DISTRICT	11-0	COUNTY	LAWRENCE	ROUTE	I-376	PROJECT		SHEET	
				PULASKI TOWNSHIP					
		1-0		MERCER	SHENAGO TOWNSHIP				
		REVISIONS

PA 208 - PULASKI  
 EXIT 5  
 (OLD EXIT PA 60 EXIT 25)

SCHEMATIC PLAN  
NOT TO SCALE

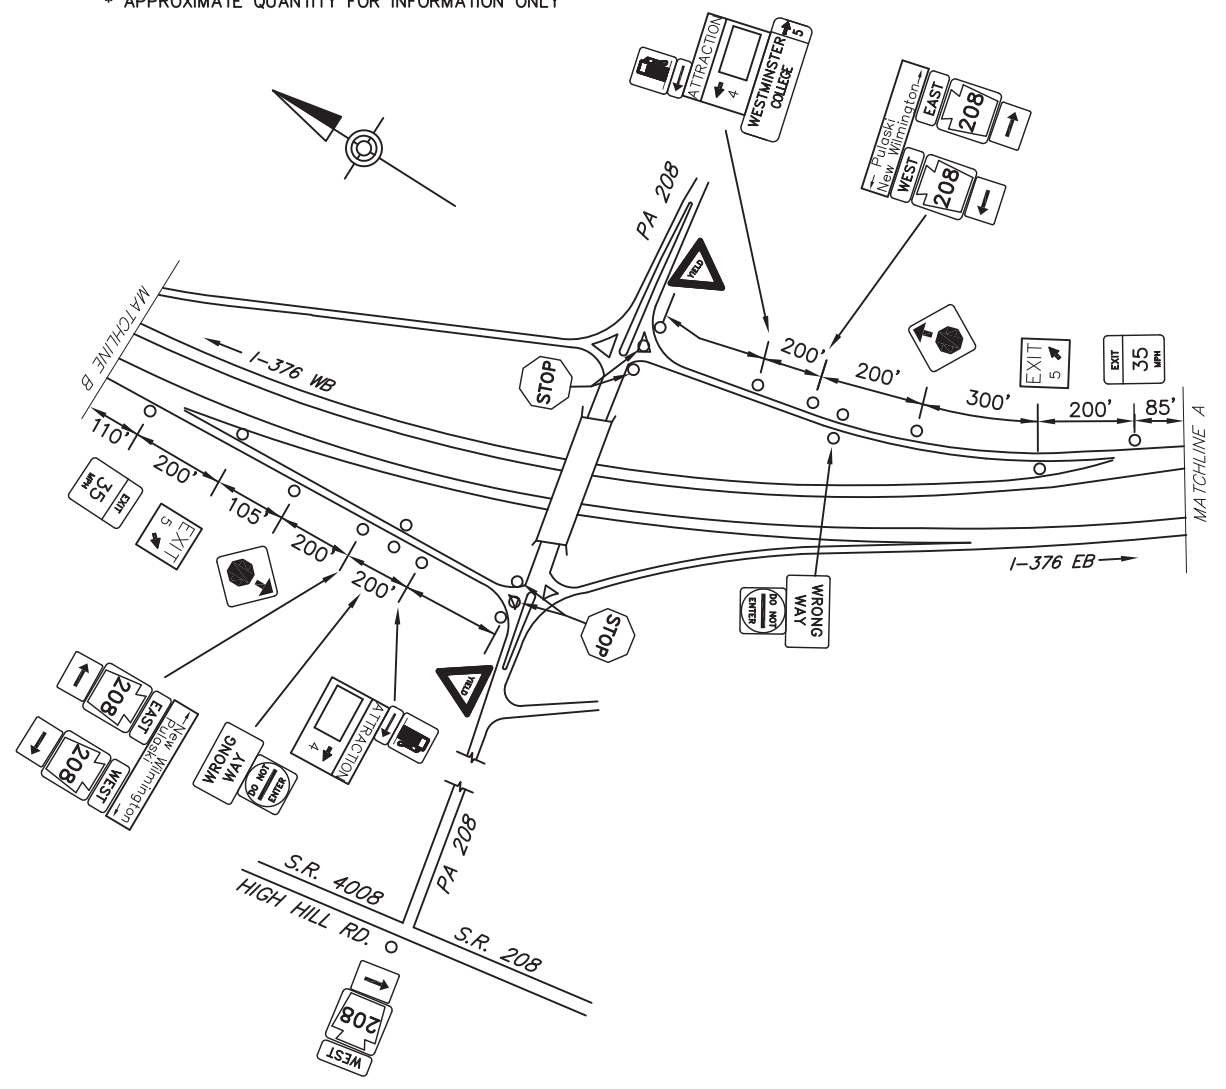
MAINLINE SIGN SHOWS EXIT 25 - SHOULD BE EXIT 5. EXIT 25 WAS CORRECT WHEN THIS WAS PA 60.
